LOWER CHURCHILL PROJECT

SITE VISIT REPORT JULY 14 TO 23, 2014.

Prepared for: Natural Resources Canada and Nalcor Energy

Date: September 19, 2014

Photo 6.7: Trial assembly of tailrace pier formwork. (July 17, 2014)

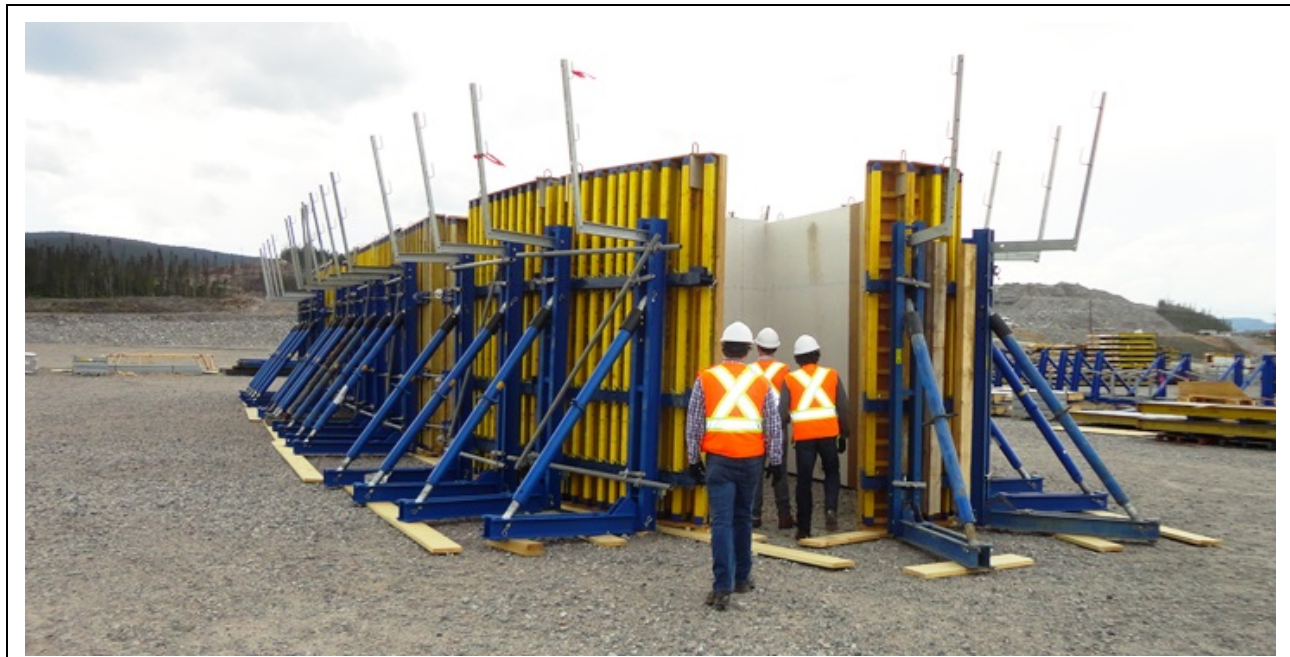
- Concrete works for the powerhouse and intake have commenced. Formwork was being erected at the time of the IE site visit (Photo 6.6 in Appendix A)
- A trial fitting of the pier formwork components was carried out (Photo 6.7 in Appendix A). The quality of the formwork was judged by the IE to be excellent.

Photo 8.1: Transmission Tower Erection and Foundations. Assembled single HVac tower unit. (July 17, 2014)

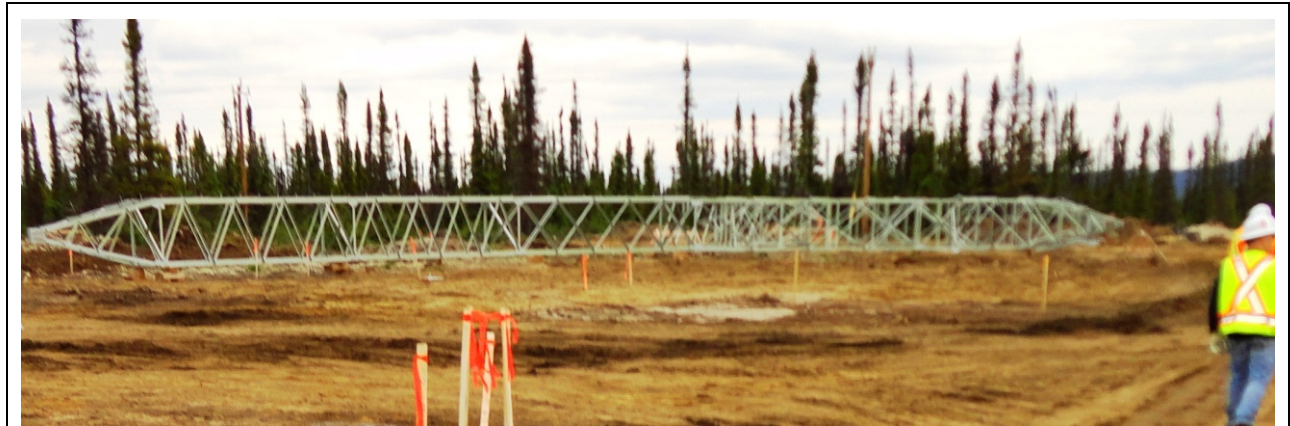
- Towers are being assembled in the field and a significant number of units (photo 8.1 in Appendix A) have been completed and are ready for erection. Vallard will have a minimum of 200 towers assembled before starting the erection. An important fact is that Nalcor have insisted that all galvanized tower assembly bolts be checked out for a proper fit in holes at the production facility. This minimizes significantly the risk of bolts misfit and the resulting schedule delay of the towers' site assembly.
